**SECTION 4.15 EVALUATION**Environmental Planning and Assessment Act 1979 (as amended)

<b>Development Application No.</b>	DA007/24 PAN 403740
<b>Subject Site</b>	Lot 7 DP263999 1A Caroline Avenue Bowenfels
<b>Proposal</b>	Detached Garage / shed (and removal of existing garage)
<b>Zoning</b>	R1 General Residential
<b>Permissibility</b>	Residential garage / shed ancillary to the existing dwelling is permissible
<b>Cost of Development</b>	\$61,801.00
<b>Applicant</b>	Fernleigh Drafting
<b>Owner</b>	Phillip Peace
<b>Notification</b>	The proposal was neighbour notified in accordance with the Lithgow Community Participation Plan 2020.
<b>Submissions</b>	A petition with twelve (12) signatures was submitted from surrounding residents in support of the proposed development. No objections have been received from the community.
<b>Affiliations and Pecuniary Interests</b>	There are no affiliations or pecuniary interests declared by the applicant
<b>Potential Reportable Donations/Gifts</b>	NIL
<b>Variations sought</b>	Lithgow Development Control Plan 2021 ( <b>DCP</b> ): <u>Part 6.4.7</u> <ul style="list-style-type: none"><li>• Maximum floor area of building and Cumulative outbuilding floor ar

Fig 3: Site plan

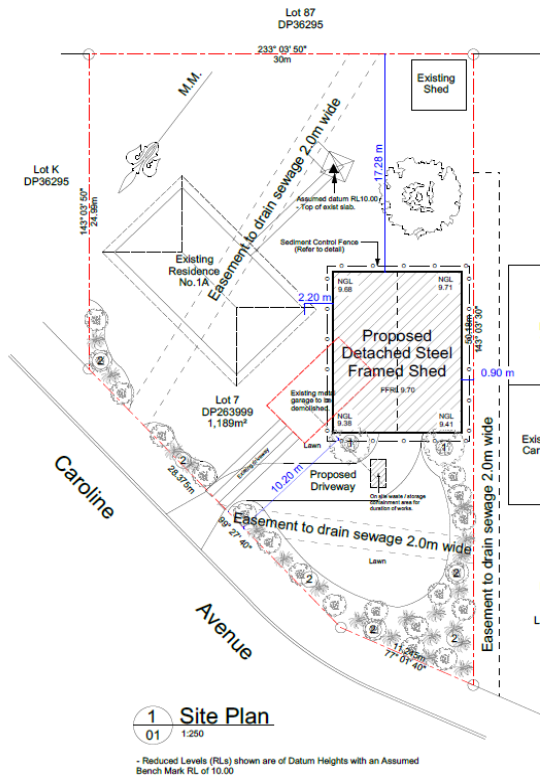
- The proposed 128m<sup>2</sup> garage / shed exceeds the maximum permissible floor area of 100m<sup>2</sup> under the DCP (exceeded by 28m<sup>2</sup>)
- The proposed 900mm side boundary setback does not comply with the required minimum 1.2m setback (applicable to a maximum permissible 3m wall height) as outlined in the DCP
- The proposed wall height of 4.2m exceeds the maximum permissible wall height of 3m detailed in the DCP by 1.2m. The roller door on the front facade is 4.2m high by 3.05m.

- The proposed driveway does not provide sufficient room to maneuver the subject bus to enter or exit the proposed garage without using the grassed area.
- The access does not allow for vehicles including the bus to leave the property in a forward direction. This would result in safety issues as appropriate sight lines cannot be maintained and conflict with pedestrians accessing the bus stop located near the property.
- Assessment of previous plans submitted for a proposed vehicular turning circle located within the front yard of the property, demonstrated that there is inadequate circulation space available to navigate, safely turn and maneuver the heavy and lengthy bus vehicle (bus approximately 11m long) to access and exit the garage / shed, as well as leave the property in a forward direction.

The proposed 900mm western side boundary setback does not comply with the DCP control of 1.2m for a maximum 3m wall height and is beyond of the scope of wall height parameters and exceeds the maximum designated wall height under the DCP by 40%. The proposed variation to the side boundary setback is not consistent with the intention of the DCP to minimise land use conflicts through siting and increased setbacks for buildings with higher wall heights and is not in the public interest.

Fig 4: Front elevation of proposed Garage / garage / shed

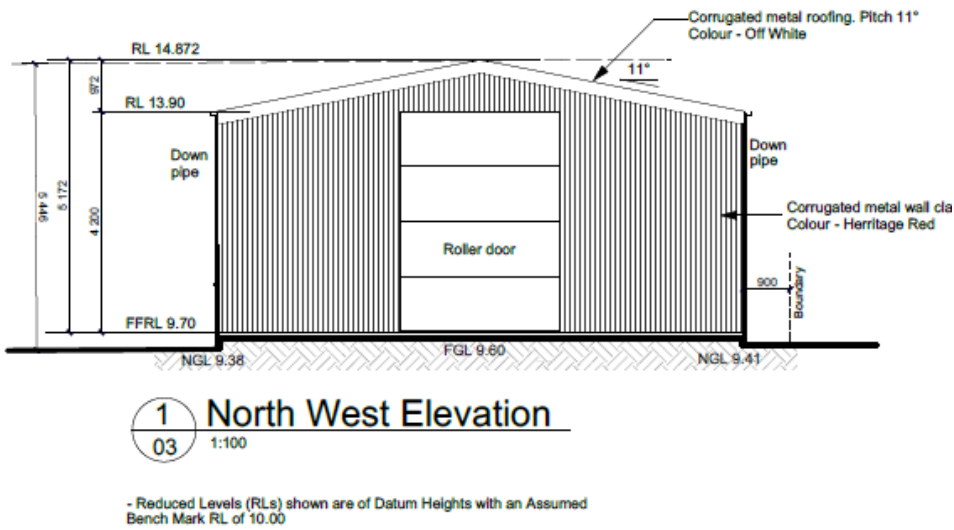
- The proposed ridge height of 5.172m exceeds that maximum permissible 4.5m requirement under the DCP by 0.672m.

The industrial design of the garage with high walls and ridge and single 4.2m high by 3m wide roller door in the middle of the 10m long front elevation is not in keeping with the existing residential garages in the area.

4. The development is not in the public interest as the proposed garage with a 4.2m wall height and 5.172m ridge height exceeds the maximum designated DCP (clause 6.4.7) wall and ridge heights of 3m and 4.5m by 40% and 15% respectively. The exceedance of the maximum wall height for the zone is a considerable variation to the control and would set a precedent for other similar garages. Justification provided for the variation of the wall height by the applicant for the storage of a large high heavy vehicle (bus approximately 11m long) in a residential area is not in keeping with the residential use of the area and existing residential garage / sheds. The proposed variation to the side boundary setback is not consistent with the intention of the DCP to minimise land use conflicts through siting and increased setbacks for buildings with higher wall heights and not in the public interest.
